Subject: Safety Recall 05V-521
(Ford Number 05S41)

SUBJECT: Safety Recall 05S41:
Certain 2006 Ford Low Cab Forward (LCF) Vehicles
Cab Entry Step Reinforcement

CERTAIN 2006 MODEL YEAR LOW CAB FORWARD (LCF) VEHICLES — STEP REINFORCEMENT BRACKET INSTALLATION

FIGURE 1

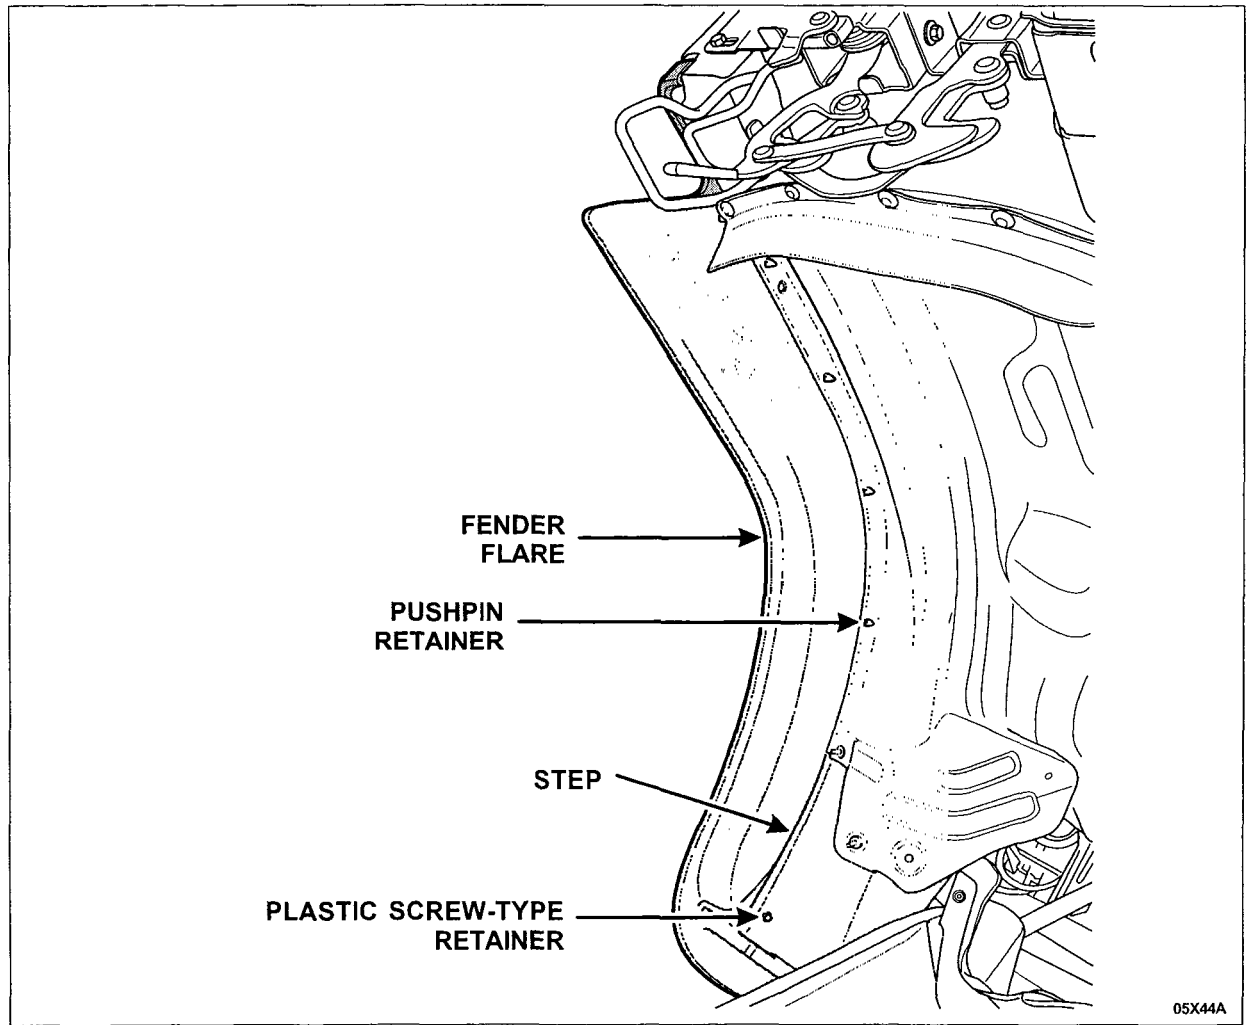
Remove the plastic screw-type retainer from the fender flare located near the step and disengage the flare from the step. Disengage the first (lowest) fender flare pushpin retainer by squeezing the prongs together and gently pulling the fender flare away from the fender. See Figure 1.

FIGURE 2

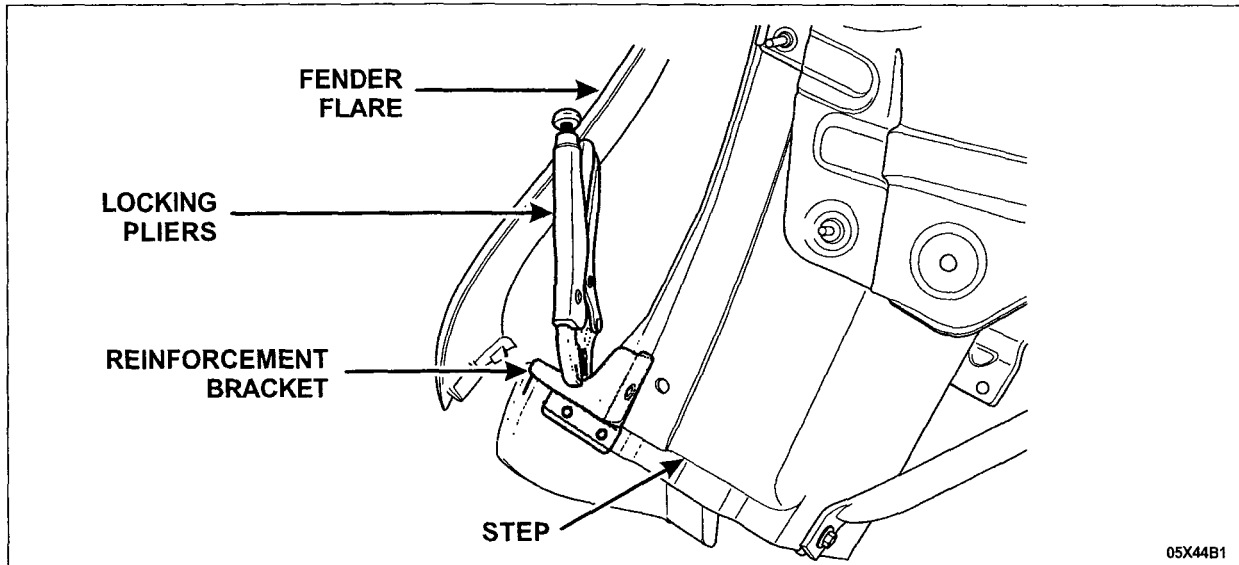
3. Position the fender flare only slightly away from the step and fender (75-100 mm or 2-3 inches), and temporarily attach the reinforcement bracket to the step using locking pliers. See Figure 2.

FIGURE 3

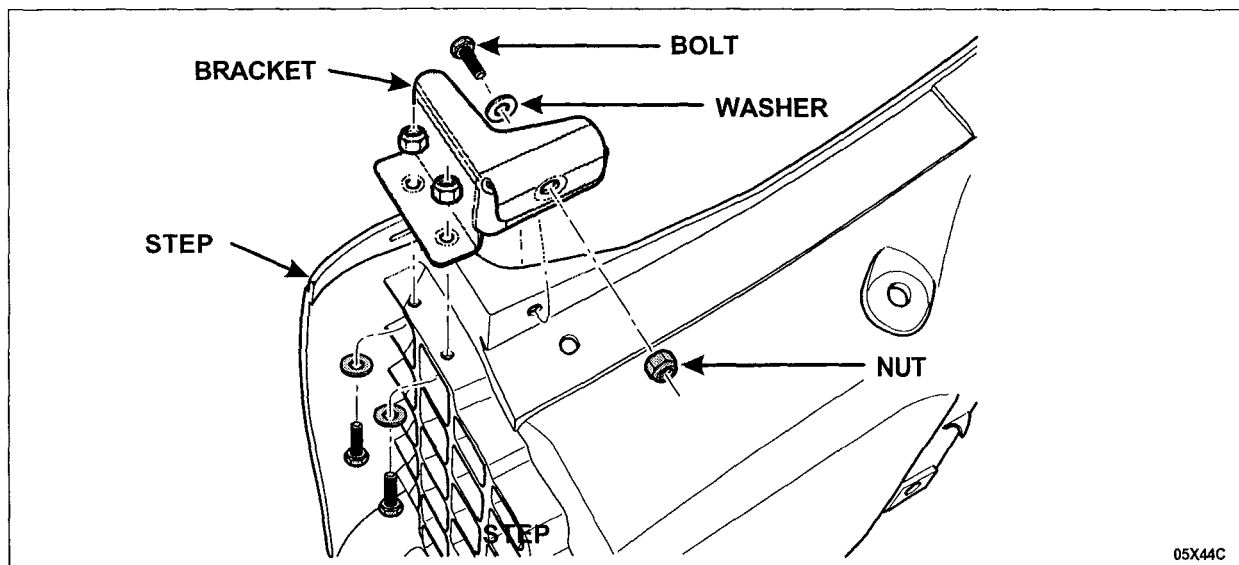
4. Using the bracket as a drilling template, locate and drill the three (3) holes using a 7 mm (1/4 inch) drill bit.
5. Using the supplied hardware, attach the bracket to the step. Insert the three (3) bolts with washers through the front of the step, then install the locknuts on the back of the step. Tighten the bolts and nuts to 11 Nm (8 lb-ft). See Figure 3.
